Title DCC PCB rev1 errata fixes		
Author Computski		
File C:\Users\julia ... tCad1 DCC board errata.dsn	Document	
Revision 1.0	Date 2022-03-28	Sheets 1 of 1

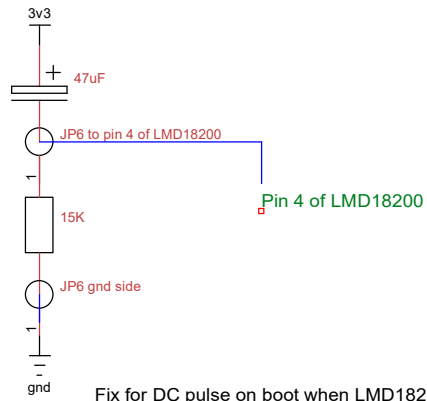
Fix for Jog wheel hardware bug.  
 The pullup via existing R5 needs a 47uF to gnd.  
 PNP and 10k are needed if you  
 want to programme the ESP

Fix for DC pulse on boot when LMD18200 on  
 board option used.  
 Remove JP6, replace with 15K.  
 Add 47uF from 3v3 rail.
